CONCEPTUAL DESIGN

144 CHARLES STREET

RELATED BEAL
DEVELOPER + GENERAL CONTRACTOR

HACIN + ASSOCIATES
ARCHITECT

INITIAL CONCEPT (01/20/2021) AND PROPOSED THIRD FLOOR PLAN

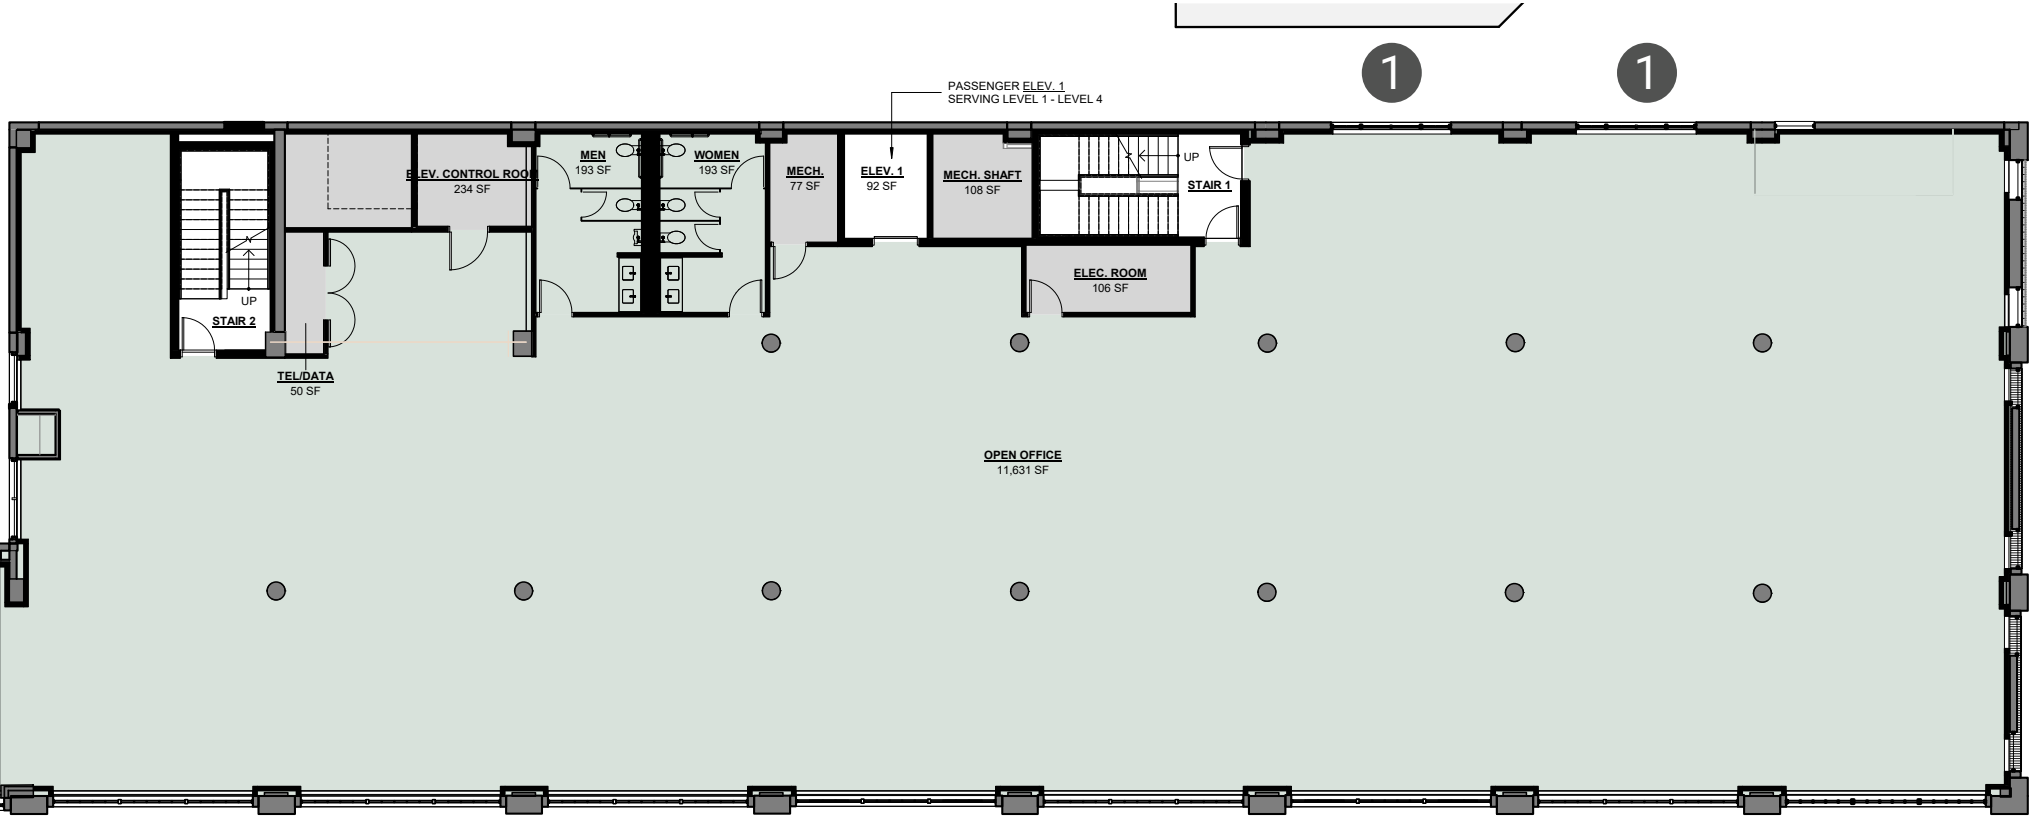
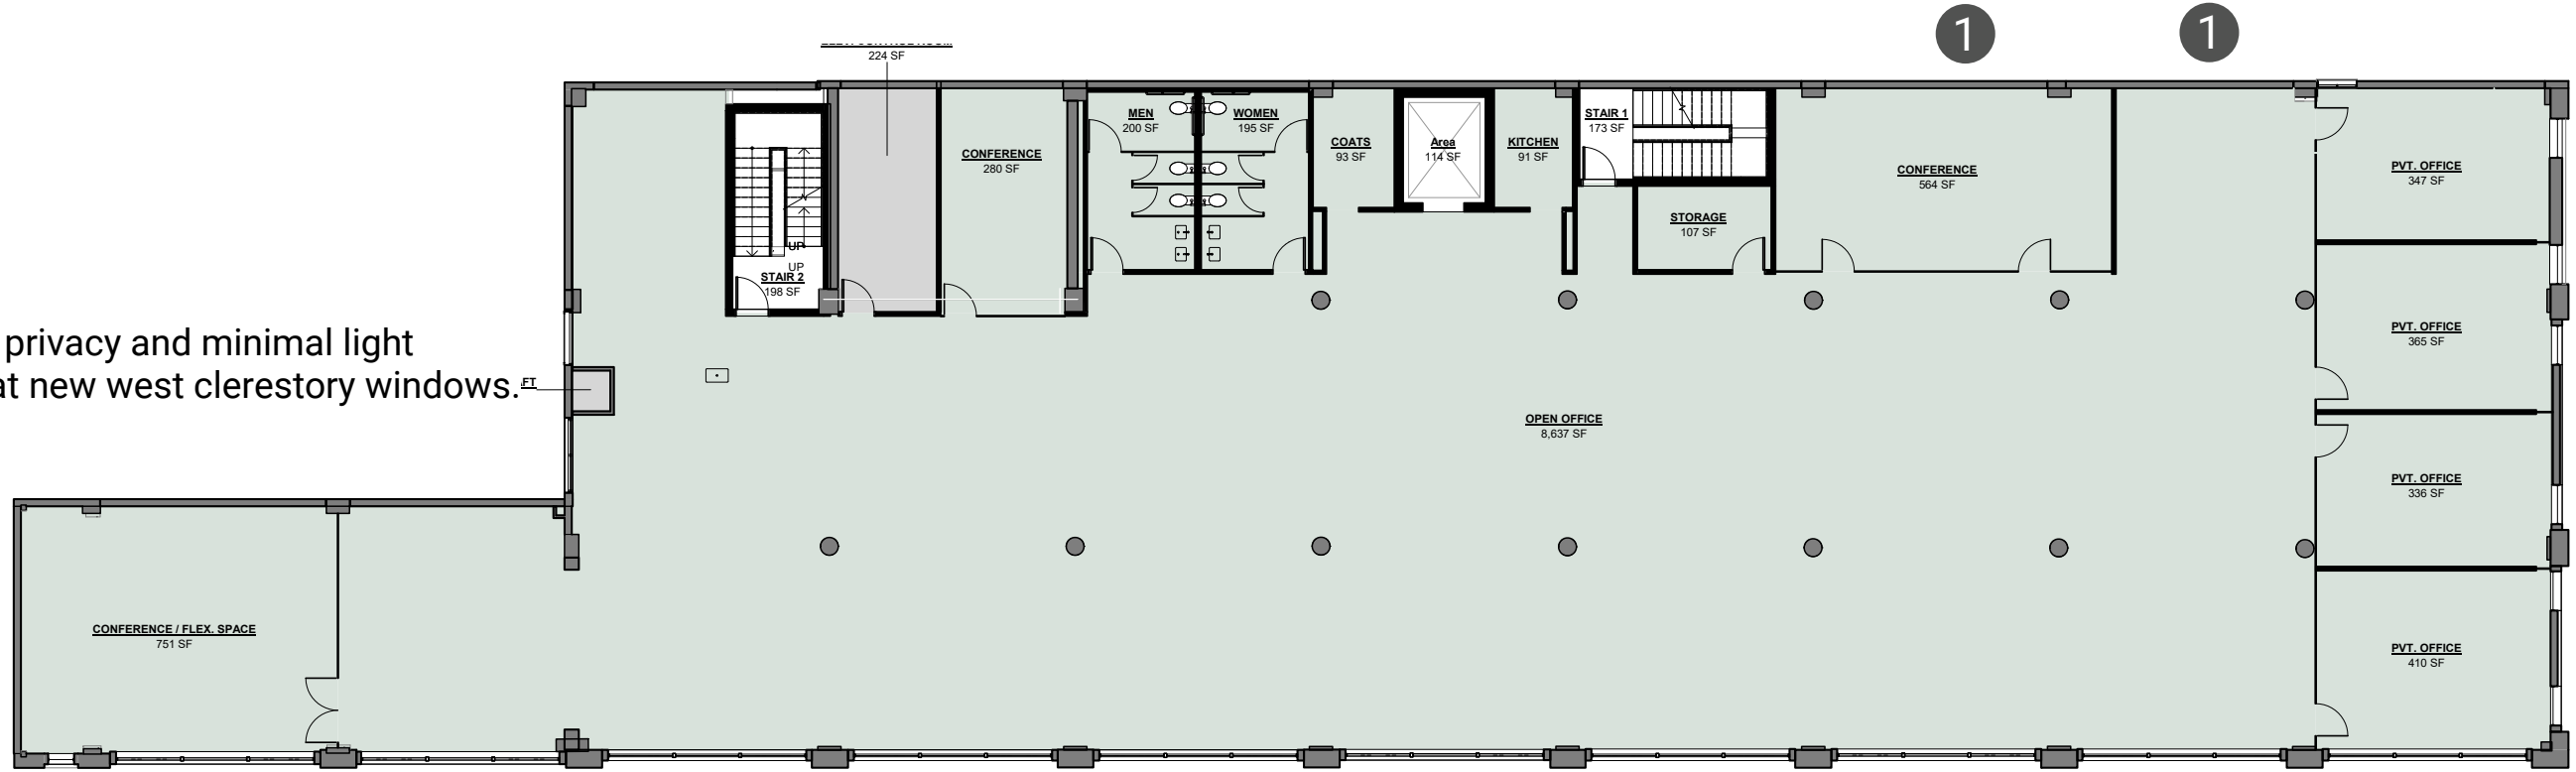
- 1. Desire for privacy and minimal light pollution at new west clerestory windows.

- 1. New windows are approximately 8' above office floor to limit visibility. Obscured glass will shield views in and out. Studying window treatments and alternate approaches to lighting.

INITIAL CONCEPT (01/20/2021) AND PROPOSED FOURTH FLOOR PLAN

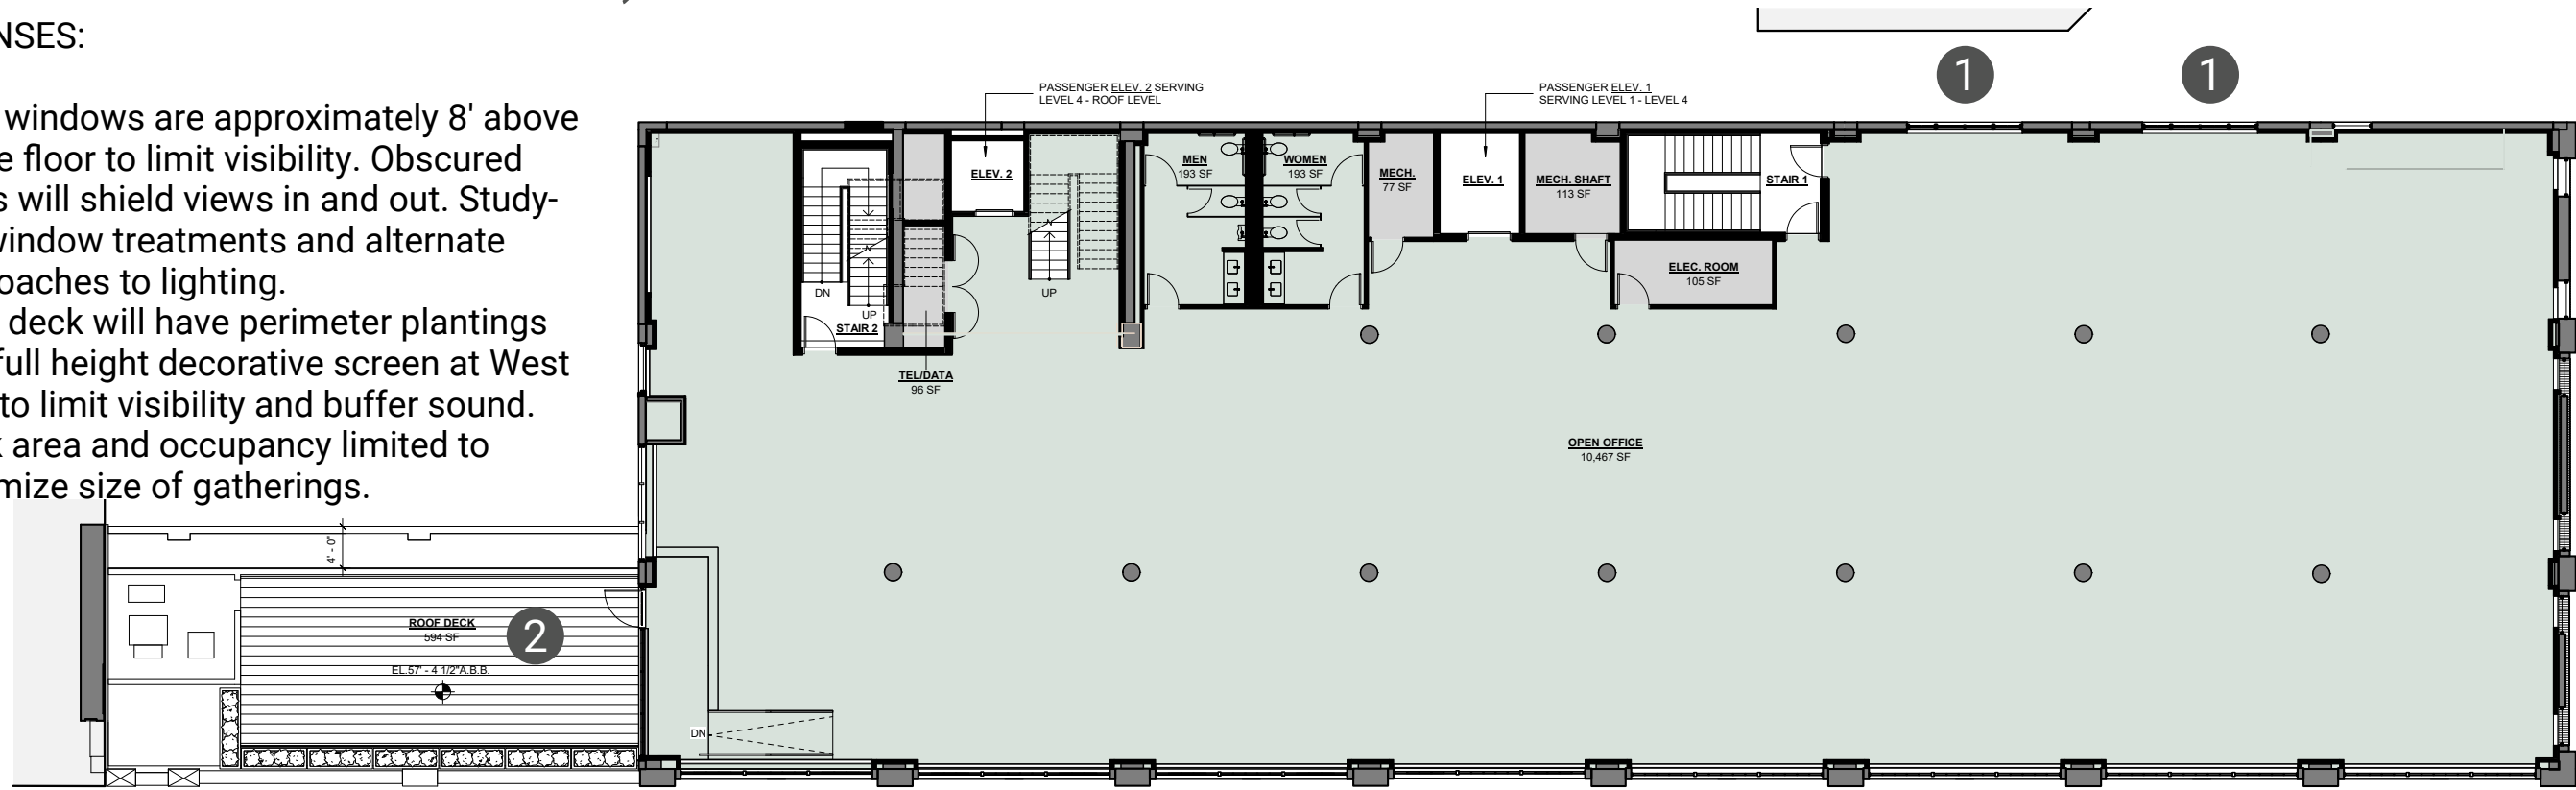
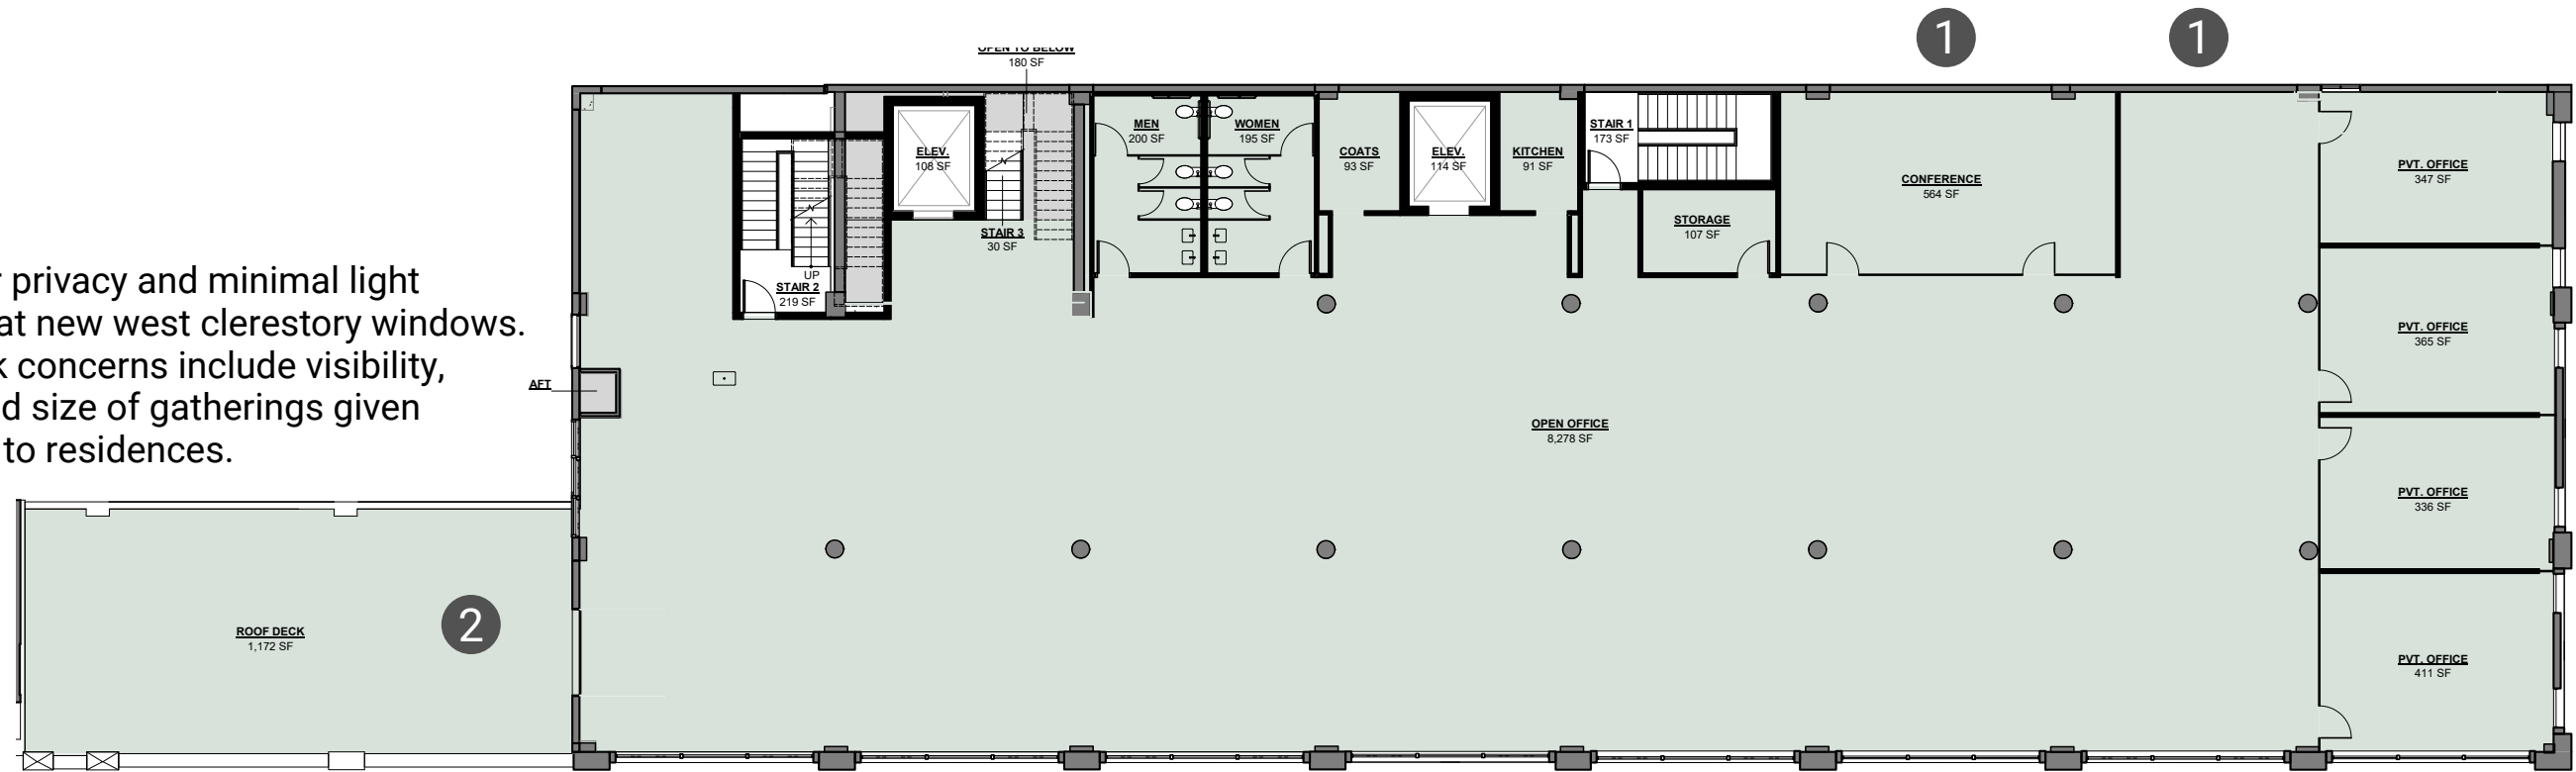
1. Desire for privacy and minimal light pollution at new west clerestory windows.
2. Roof deck concerns include visibility, sound, and size of gatherings given proximity to residences.

1. New windows are approximately 8' above office floor to limit visibility. Obscured glass will shield views in and out. Studying window treatments and alternate approaches to lighting.
2. Roof deck will have perimeter plantings and full height decorative screen at West side to limit visibility and buffer sound. Deck area and occupancy limited to minimize size of gatherings.
